3. Revised Project Amendments

3.1 Rail and Road Infrastructure

**NEW ACLAND COAL MINE
STAGE 3 PROJECT**

**Figure 3.1-A - Revised Project
Amendment**

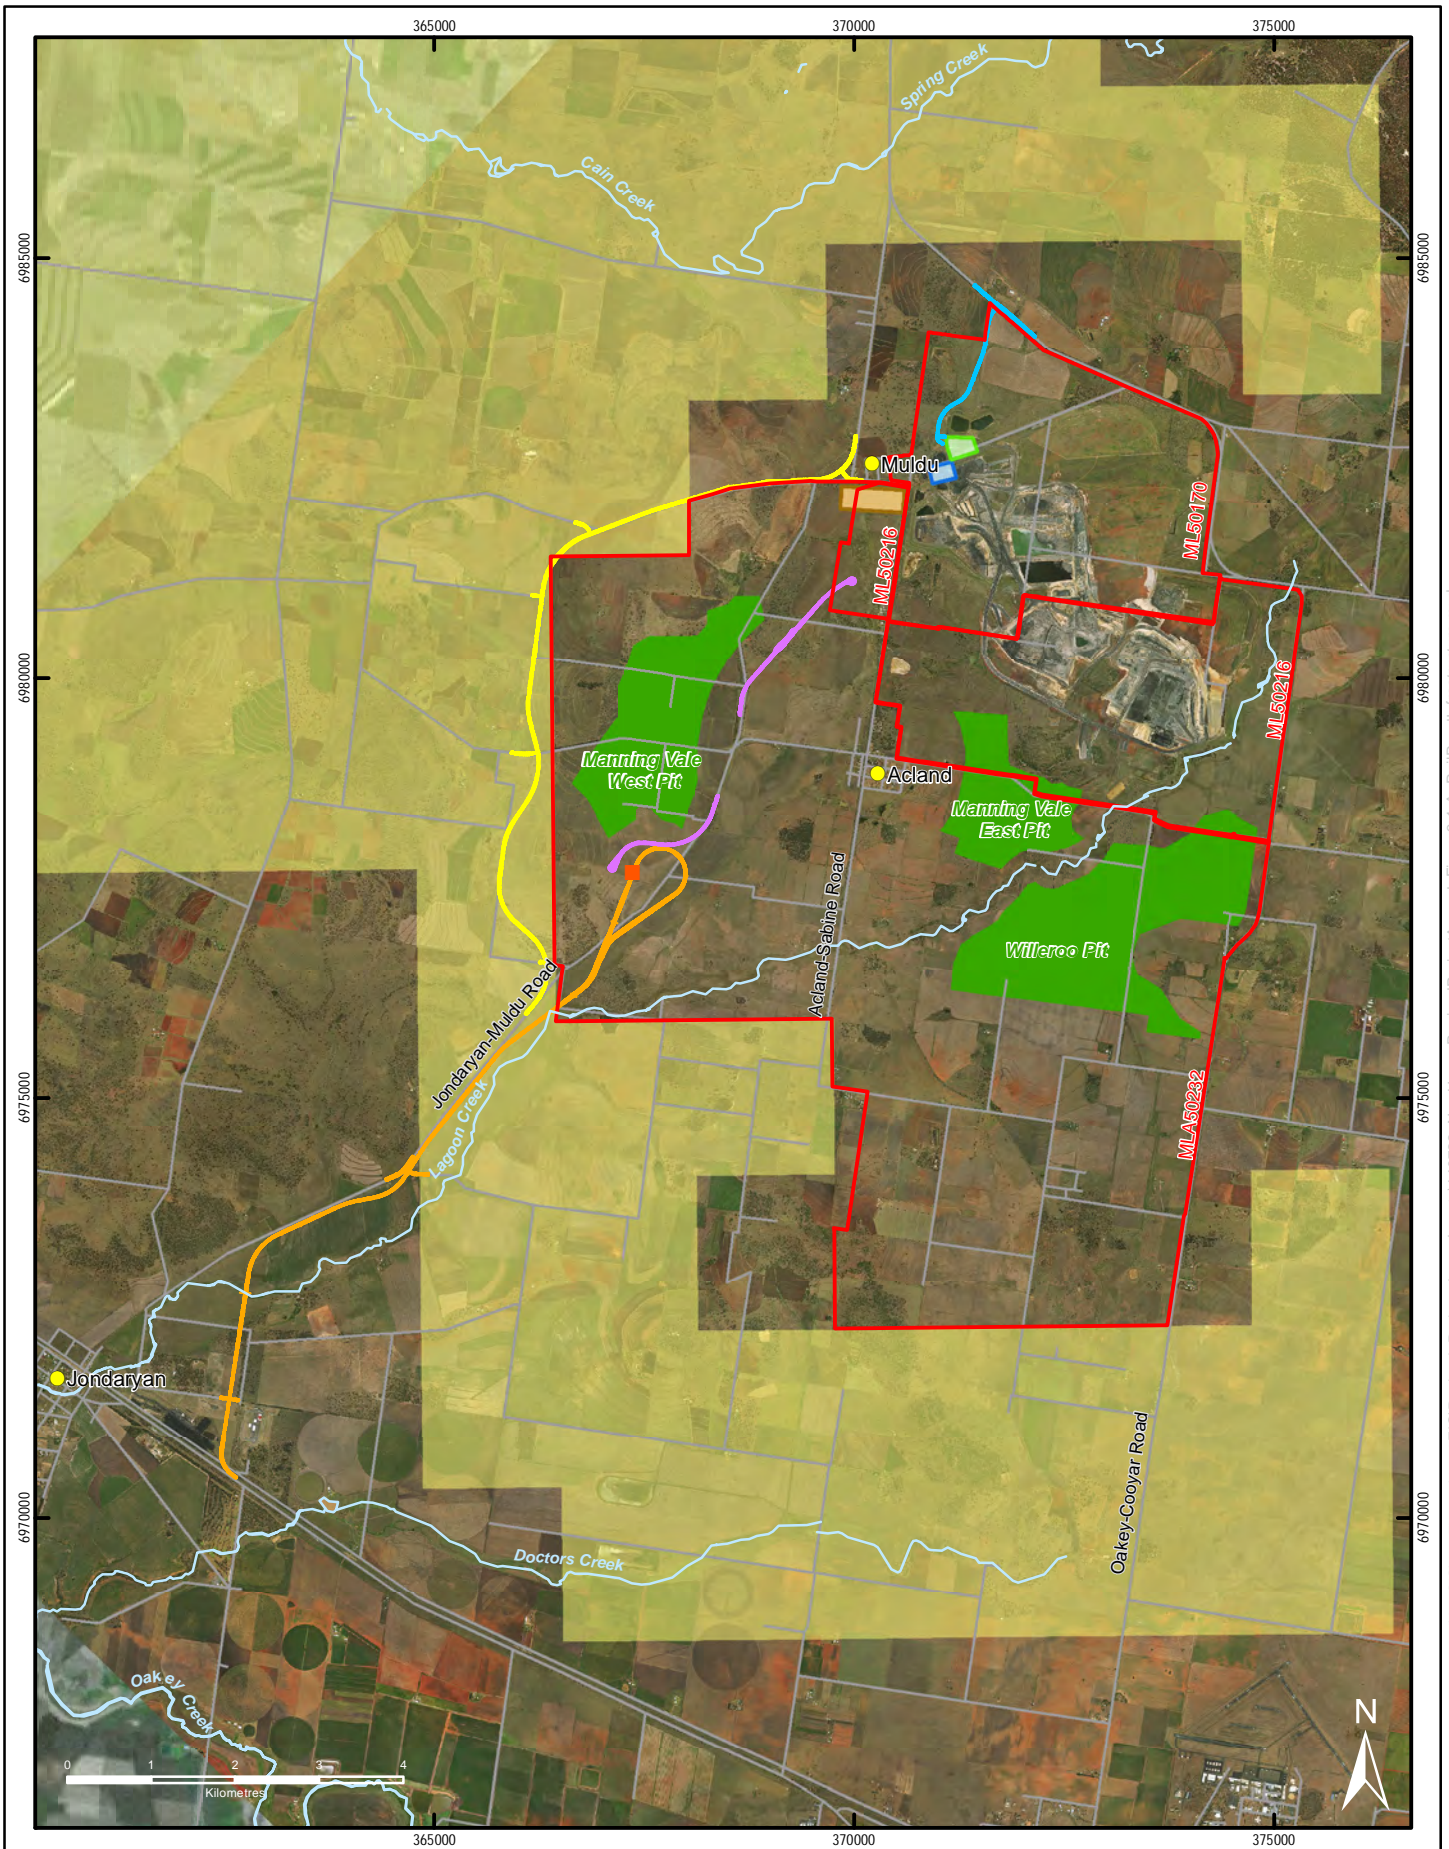
As a result of this phase, **Figure 3.1-A** depicts the revisions made to the main access to the mine, the alignment of the Jondaryan-Muldu Road and the alignment of the rail spur and balloon loop and location of the new Train Loadout Facility (TLF) for the revised Project. A description of the amendments to the revised Project is described in **Table 3.1-A**. In addition, the internal haul road from the Materials Handling Facility (MHF) to the new TLF will remain in place for the duration of the revised Project. Other internal haul roads used for the transportation and raw coal from the mine pit to the Run-of-Mine (RoM) Pad and light vehicle access will be periodically constructed in front of the mine path to allow for access and transportation of raw coal. These minor changes will not result in an increase in environmental nuisance or harm.

Revised Project Amendment Component	Description of Amendment to that described in draft EIS
Main Access to the revised Project	The original main access to the revised Project was along Cherry's Road to the north of the revised Project site. Feedback from the public consultation and the Department of Transport and Main Roads raised safety concerns with this road intersection. NAC revised this access and propose to construct a new road off the Peachey-Maclagan Road which will enter into the new Mine Industrial Area (MIA). The new road will be designed to the appropriate standards to transport light vehicles into the revised Project site.
Rail Spur and Balloon Loop and TLF location	The layout of the rail spur and balloon and location of the new TLF has changed as to that presented in the draft EIS based on the FEED phase. The amendment to the original alignment will now result in the new TLF being on the western side of the balloon loop as opposed to the eastern side. There will also be a slight adjustment to the alignment at the intersection of the Jondaryan-Muldu Road and Childs Road to meet rail design requirements. For additional information regarding this matter refer to Section 5.1.3.2 of the AEIS.

Jondaryan-Muldu Road Diversion	The original alignment to the Jondaryan-Muldu Road will be slightly changed at the intersection of Cooke-McGovern Road and the Jondaryan-Muldu Road to minimise property impacts and accommodate natural drainage channels. The alignment will be moved to the east by approximately 200 m. In addition, the alignment near Muldu will join the Muldu-Plainview Road north of the revised Project site.
